Access Compliance Report

Public Rights-of-Way

(Curb Ramps)

Intersection ID: 16126	Main Street: E_W_T_HARRIS_BV	Cross Street: IDLEWILD_RD	Location: SE
ADA ID: 79C3A3D929DB	Ramp Type: Perp	Initial Pass/Fail: Fail	Overall Compliance: No
		Severity Score: 25

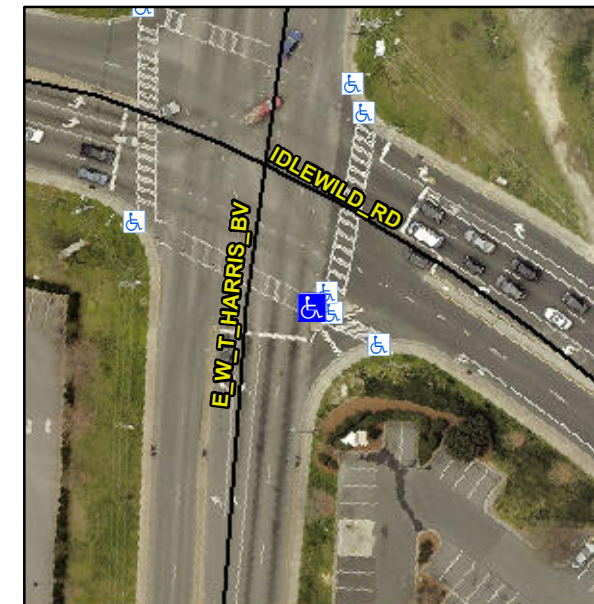
R304.2.2

Compliance	Description	Data	Compliance	Description	Data
N/A	Ramp Length (in)	53.0	No	Ramp Slope (%)	16.1
Yes	Ramp Width (in)	48.0	Yes	Ramp XSlope (%)	0.7
N/A	Flare Type LT	N/A	N/A	Flare Type RT	N/A
N/A	Flare Slope LT (%)	N/A	N/A	Flare Slope RT (%)	N/A
N/A	Flare Traversable LT?	N/A	N/A	Flare Traversable RT?	N/A
N/A	Landing Length (in)	N/A	N/A	DWS Provided?	N/A
N/A	Landing Width (in)	N/A	N/A	DWS Contrast?	N/A
N/A	Landing Slope (%)	N/A	N/A	DWS Length (in)	N/A
N/A	Landing X Slope (%)	N/A	N/A	DWS Full Width?	N/A
N/A	Landing Curb? (Y/N)	N/A	N/A	DWS Offset (in)	N/A
N/A	Shared Landing?	N/A			
N/A	Gutter Ponding?	N/A	N/A	Gutter Slope (%)	N/A
N/A	Gutter Lip Ht (in)	N/A	N/A	Gutter X Slope (%)	N/A
N/A	Painted X Walk1?	Yes	N/A	Painted X Walk2?	N/A
	X Walk 1 Direction	To NW		X Walk 2 Direction	N/A
N/A	X Walk 1 Width (in)	107.0	N/A	X Walk 2 Width (in)	N/A
	X Walk 1 Slope (%)	0.9		X Walk 2 Slope (%)	N/A
	X Walk 1 X Slope (%)	1.4		X Walk 2 X Slope (%)	N/A

Remove & Replace Entire Ramp.
